UNITED STATES PATENT AND TRADEMARK OFFICE

Office Action Summary	Application No. 10/576,963	Applicant(s) PAUL ET AL.	
	Examiner ERIN B. SAAD	Art Unit 1793

DETAILED ACTION

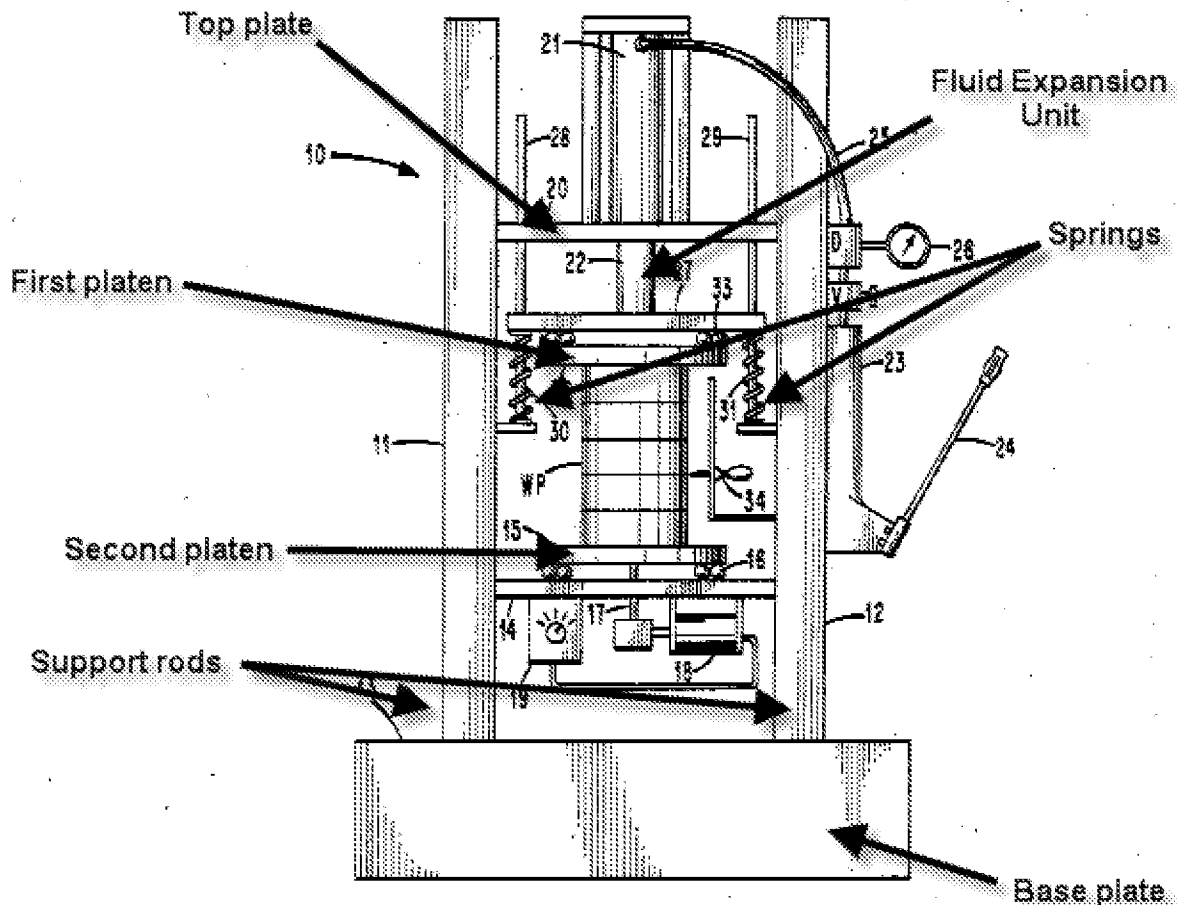
8. Claims 67 are rejected under 35 U.S.C. 102(b) as being anticipated by Barry, Jr. et al. (4,689,108).

Regarding claim 67, Barry discloses that the thermally assisted bonding unit further comprises a frame having a base plate 13, a top plate 20, and support rods 11, 12 positioned between and coupling the base plate and the top plate, the fluid expansion unit 22 positioned between the base plate and the top plate; and a first platen 32 and a second platen 15 positioned between the at least one fluid expansion unit and the bottom plate, the first platen contacting an upper surface of the laminae and the second platen contacting a lower surface of the laminae (shown below).
